RE: CUYAHOGA COUNTY
VILLAGE OF MAYFIELD
CONSTRUCTION STORM WATER
PERMIT NO: 3GC06488*AG
DEACONS CHRYSLER JEEP DODGE

On Thursday, August 8, 2013, I conducted an inspection at the above mentioned site to determine compliance with the Ohio EPA General Storm Water National Pollutant Discharge Elimination System (NPDES) Permit for Construction Activities #3GC06488*AG. Accompanying me on my inspection was Tom Cappello, City Engineer for Mayfield Village. Our records indicate that storm water discharges from this site are authorized under the general NPDES permit for construction activities granted on May 1, 2013.

Figure 5: Sediment has tracked off-site and into the street.

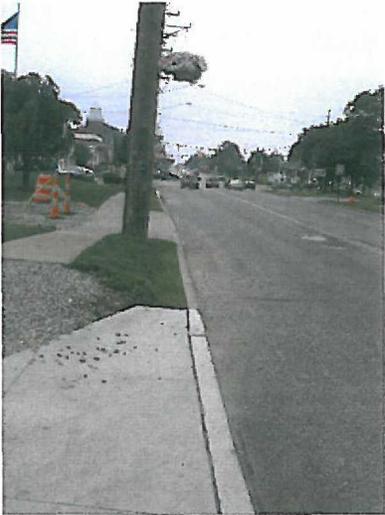
- **The Rock Construction Entrance was inadequate, resulting in sediment tracking off site.** Specifications for a Rock Construction Entrance can be found in Chapter 7 of the *Rainwater and Land Development Manual, Ohio's Standards for Stormwater Management, Land Development and Urban Stream Protection* (Ohio Department of Natural Resources, 2006). (**Figure 5**)
